Supplementary information with regard to the experimental conditions as the study of False Reaction scenarios

- Answer to the questions from industry in AEBS-11-04 -

National Traffic Safety and Environment Laboratory

Draft Scenario 1

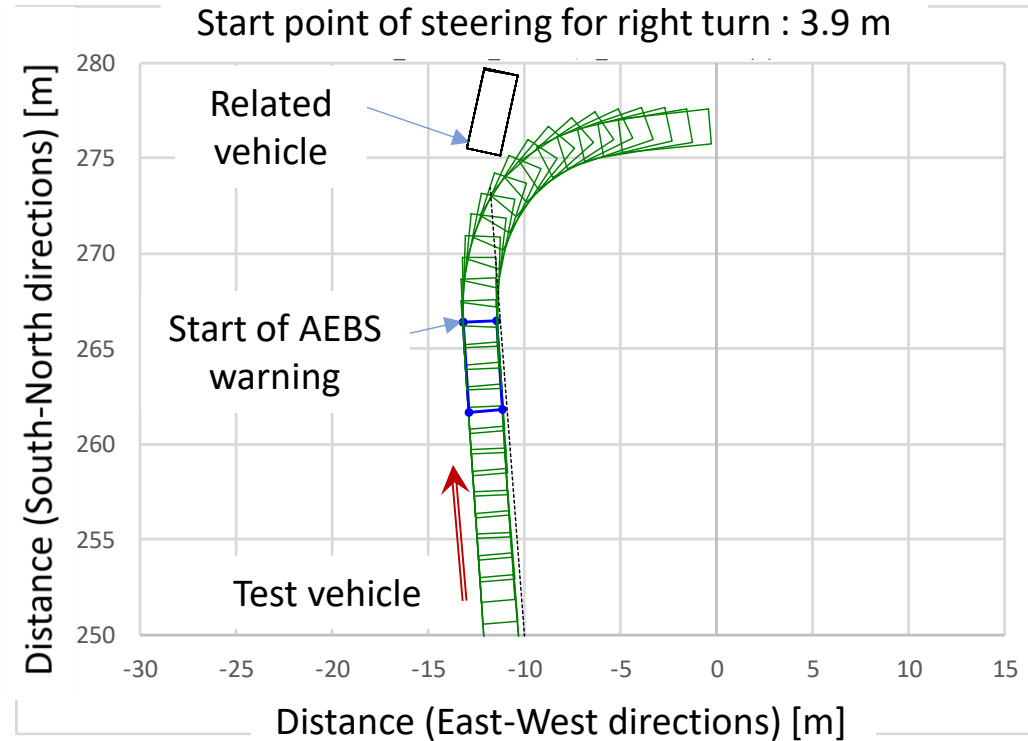
- Trajectory of VUT?
 - ➔ It was not strictly defined. Velocity (20km/h), start point of steering for right turn and lateral position (center of the lane) before right turn were defined.

- Lane width?

- Position of the VUT before and after turning ➔ lat. position from VUT and Target?
- Position of the stationary target (in the intersection), angle of the stationary vehicle?

- v_constant?

➔ It was approximately 3m.

➔ Lat. position of VUT was approximately the right-side end in the lane.
Lat. Position of Target was specified. (See below figure.)

➔ Yes

Draft Scenario 2

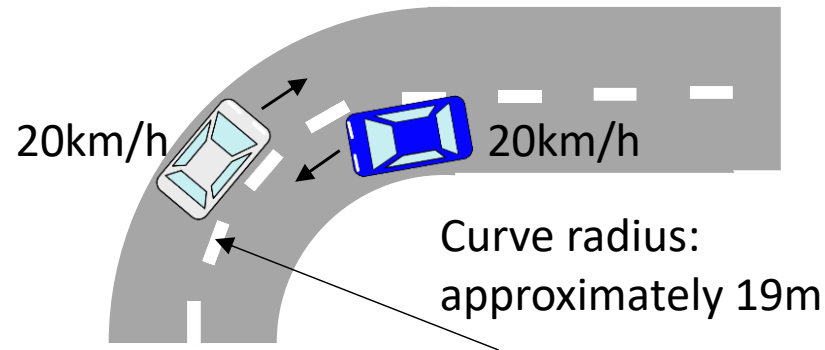
- Position of the VUT in the lane?
 - ➔ Both VUT and Related vehicle were approximately center of the lane.
- Lane width?
 - ➔ Approximately 3.5m.
- Trajectory of the GVT
 - ➔ It was not strictly specified (small radius left turn).
- v_{VUT} and v_{GVT} constant?
 - ➔ Yes
- Initial condition?
 - ➔ Both VUT and Related vehicle were stationary. The distance between the two vehicles was more than 100 m.

Draft Scenario 3

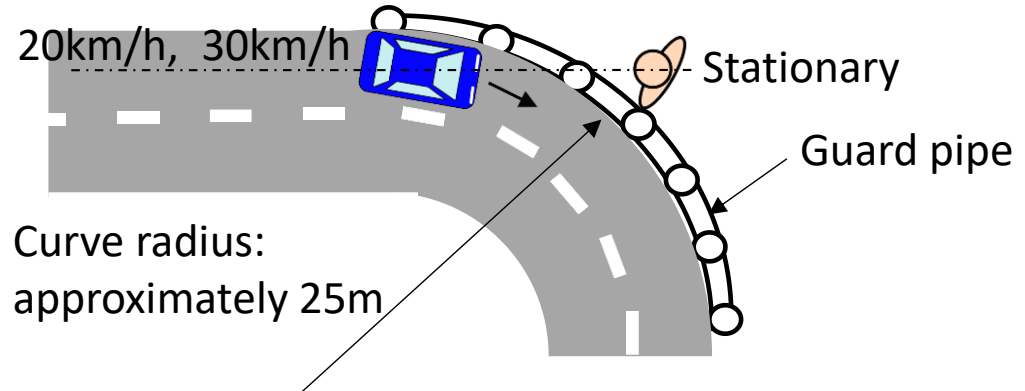
- Position of the vehicles (Targets and objects)?
➡ Approximately center of each lane.
- Inner and outer radius?
➡ Inner radius was approximately 16 m, and outer radius was approximately 22 m.
- Trajectory of the vehicle?
➡ Both VUT and related vehicle drove in approximately center of each lane .
- Meeting point of GVT and target?
➡ Meeting point was approximately middle of the curve.

Draft Scenario 4

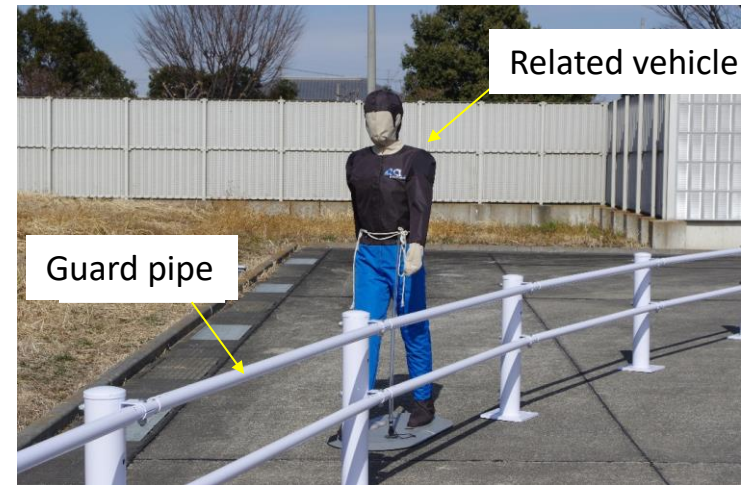
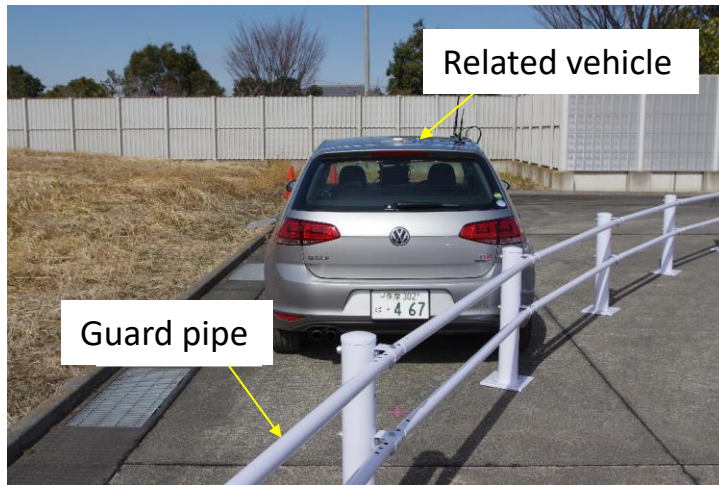
- Position of the vehicle (Targets and objects)?
 - ➔ VUT drove approximately center of the lane. The position of the stationary target was on the extension line of the center in the straight section of the lane.
- Detailed description of „guard pipe“?
 - ➔ Length of each guard pipe (straight shape) was 2 m, and diameter was 48.6 mm (exactly same type of guard pipe as the one which is used in actual road)
- Adult dummy (ISO19206-2)?
 - ➔ Yes
- Position of the stationary (+ viewing direction)?
 - ➔ The stationary target was located just outside of the guard pipe.

- Position of the stationary (+ viewing direction)?
➡ The stationary target was located just outside of the guard pipe.
(See below picture)

Draft Scenario 5

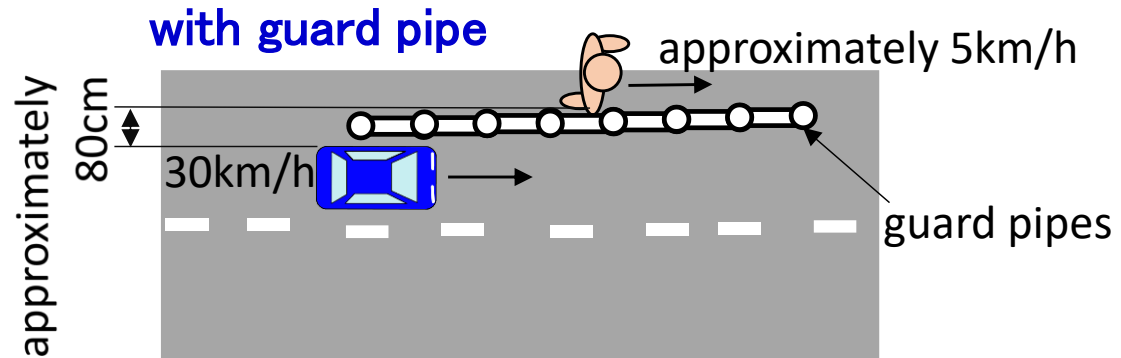
- Distance between the left side of the test vehicle and the guard pipes is approximately 50 cm.
- The pedestrian walks along the guard pipes. The distance between the left side of the test vehicle and pedestrian is approximately 80 cm.
- Description of the guard pipe
 - ➔ Length of each guard pipe (straight shape) was 2 m, and diameter was 48.6 mm (exactly same type of guard pipe as the one which is used in actual road)
- Adult dummy (19206-2)?
 - ➔ No. A real pedestrian was used.
- Position of the guard pipe to the vehicle or to the pedestrian
 - ➔ From the guard pipe to the vehicle was approximately 50 cm, and from guard pipe to the pedestrian was approximately 20 cm.
- Tolerances (only positive ones)?
 - ➔ Tolerances of VUT were +/-0.1m (lateral position) and +/-1 km/h.

Draft Scenario 6

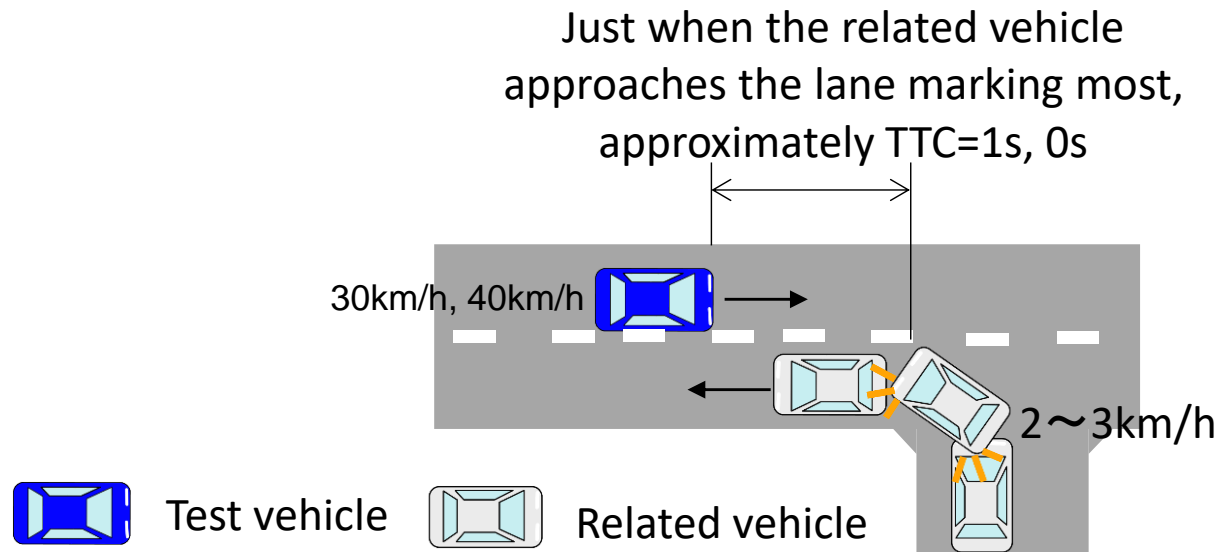
- Material of the signs?
 - ➡ The road construction sign was steel (and the arrow sign was plastic).

- Dimension of the material/signs?
 - ➡ Width was approximately 0.55 m, height was approximately 1.55 m.

- Position of the material?
 - ➡ Approximately center of the lane
- Trajectory of the VUT (v_{lat} , radius,...)
 - ➡ Trajectory of the VUT was not strictly defined.
- Position of the VUT in the lane
 - ➡ Lateral position before lane change was center of the lane (tolerance ± 0.1 m).
- Lane width
 - ➡ Approximately 3.5 m
- Use of Indicator?
 - ➡ No
- Physical limitation (steering at 0,8s)?
 - ➡ The condition of 0.8s was close to physical limitation.
